RE: *Additional Information for Proposed Site Investigation*, Jagemann Plating Company,
1324 South 26th Street, Manitowoc, WI 54220; BRRTS #02-36-555544

On behalf of Jagemann Plating Company., Robert E. Lee and Associates, Inc., (REL) is providing a response to your e-mail, dated May 24, 2017, regarding the Site Investigation Update Report (dated April 24, 2017) for Jagemann Plating Company, 1324 South 26th Street, Manitowoc, Wisconsin (the Site). The e-mail provides comments/questions regarding our proposed site investigation. The Wisconsin Department of Natural Resources (the Department) comments/questions are listed below in bold italics and REL's response is listed beneath.

**ATTACHMENT "B" 100415
FINAL DEPRESSURIZATION TESTING
Post-SSD Vapor extraction installed 102115**

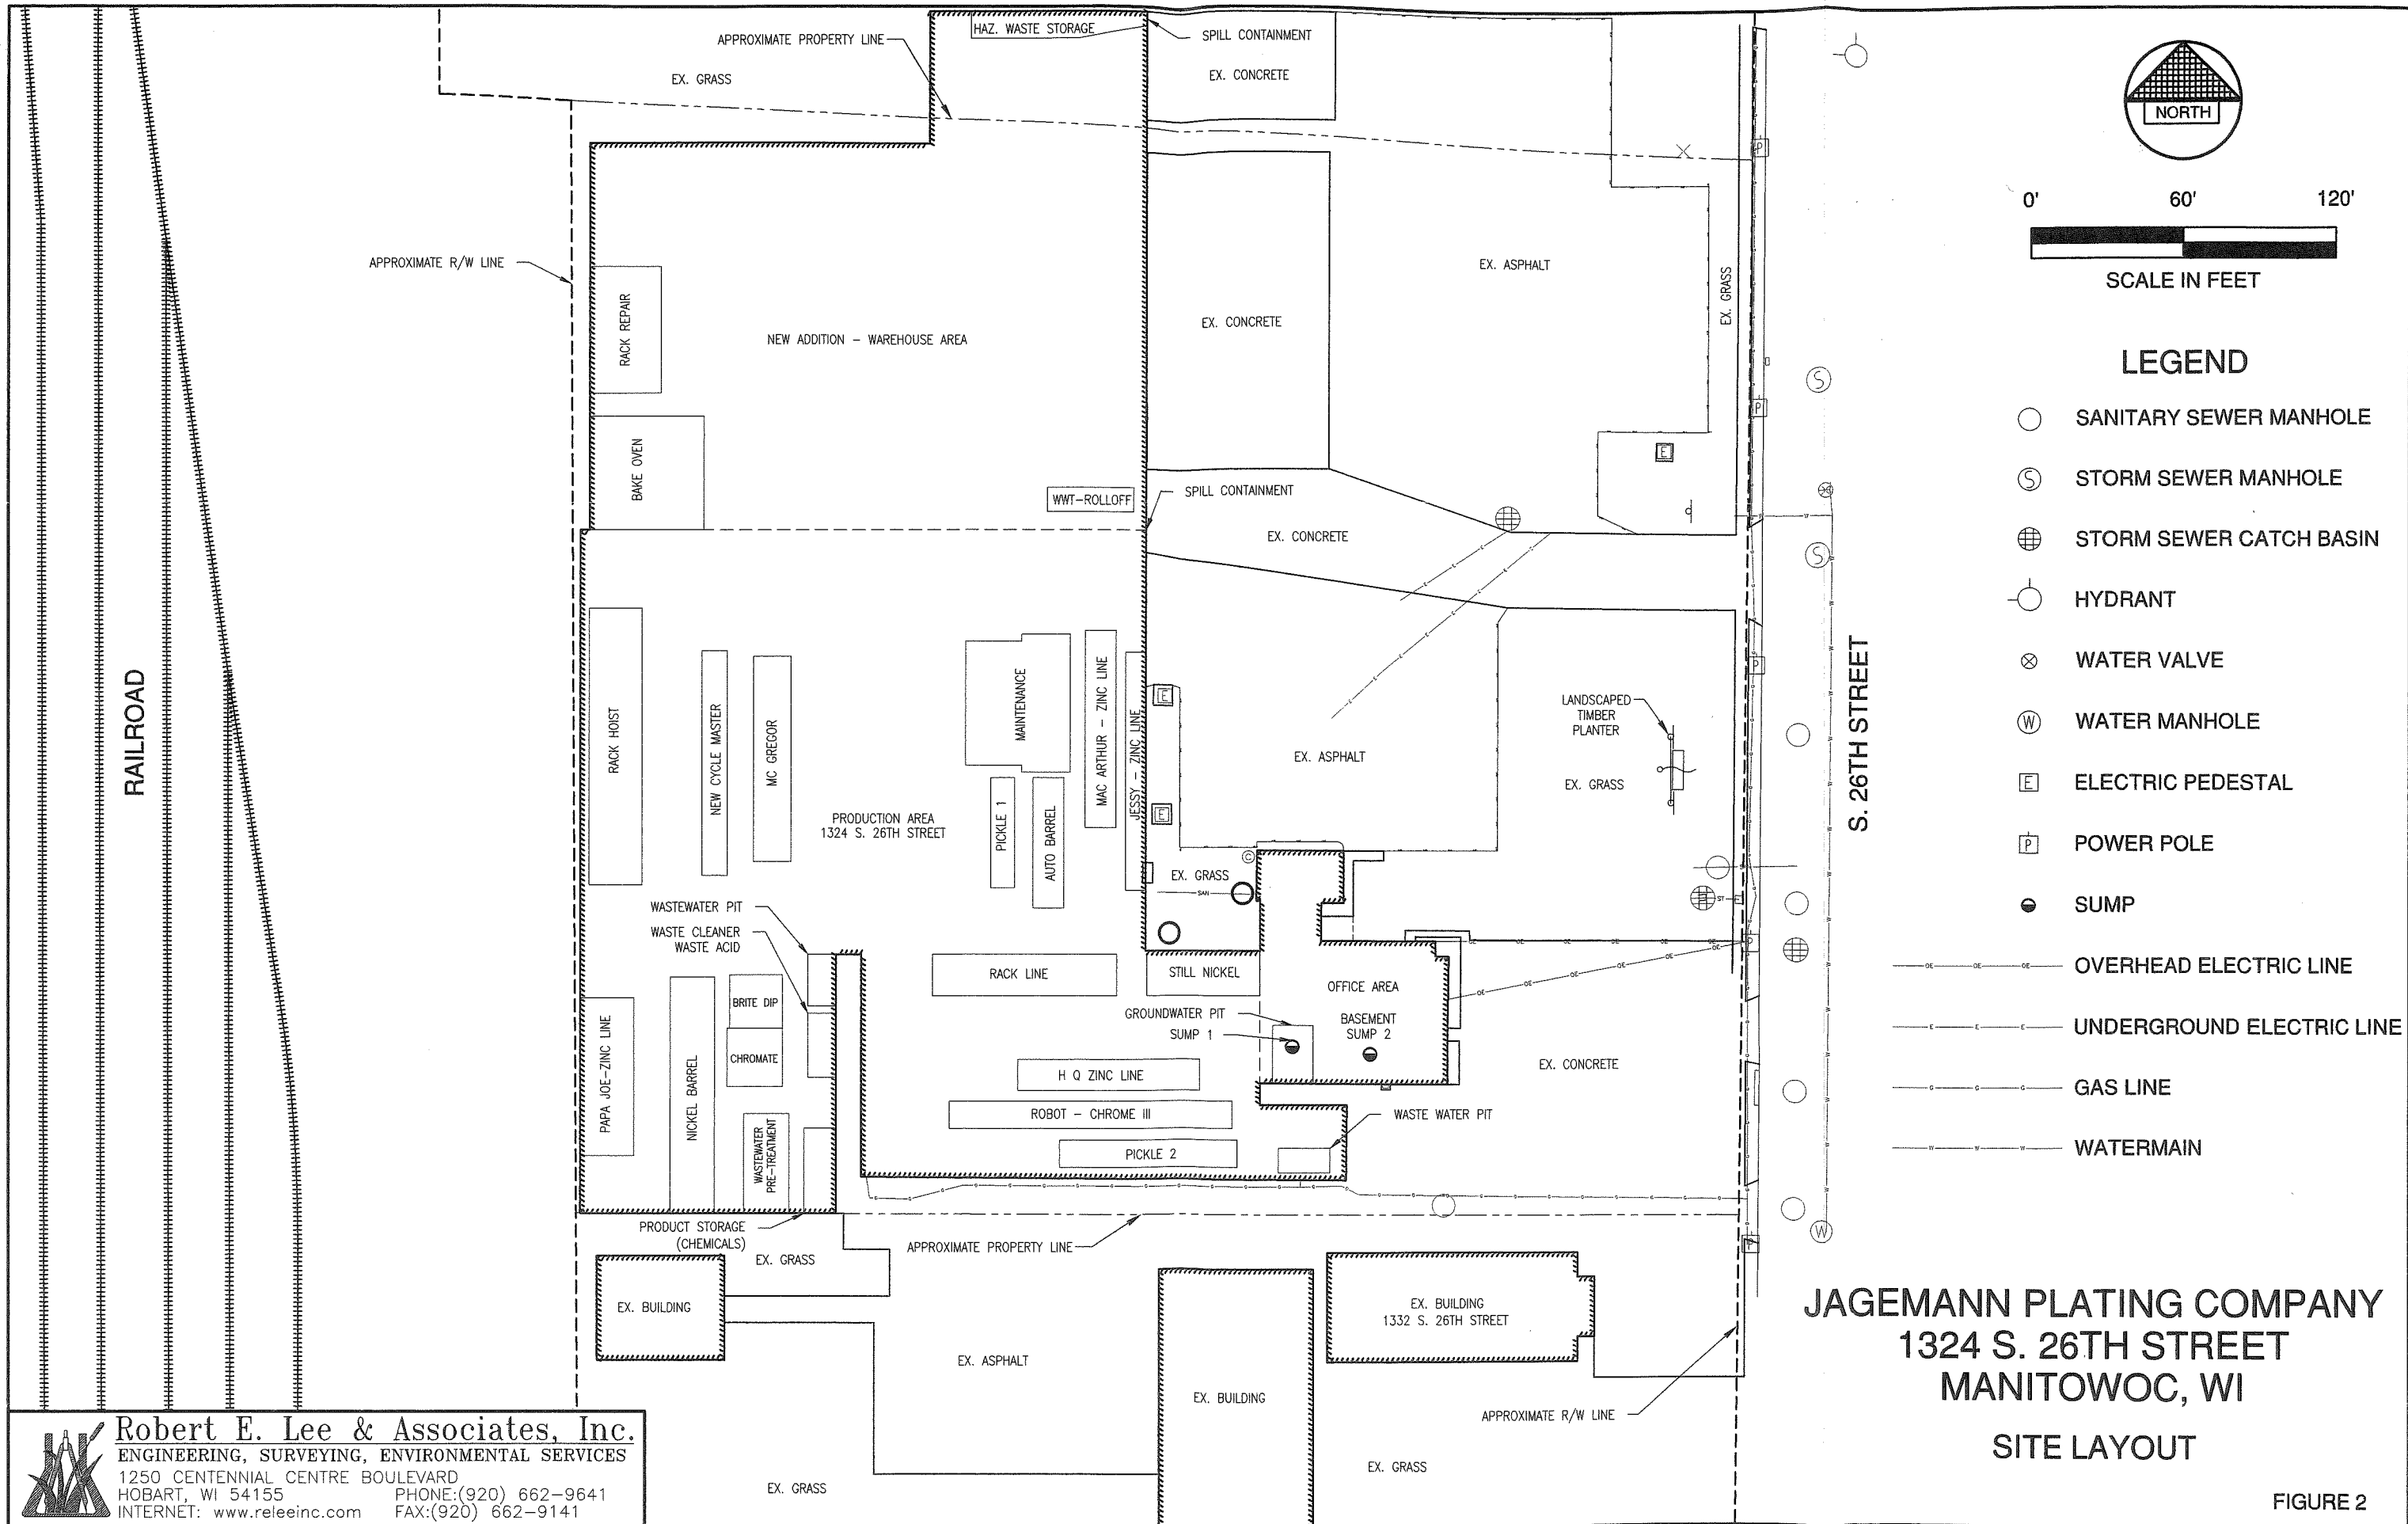
3. ***A vapor mitigation system was installed. Documentation of the communication testing, vapor mitigation system information, location of the system, etc., needs to be submitted.***

A vapor sub-slab depressurization system (SSDS) was installed by Radon Abatement on October 21, 2015 to mitigate vapors intruding into the administrative offices area of the building from beneath the foundation. A *SSD Vapor Extraction Final Report* (dated November 4, 2015), prepared by Radon Abatement, documenting the system installation is included in Attachment B.

The entire sub-slab appears to be efficiently
depressurized and ventilating
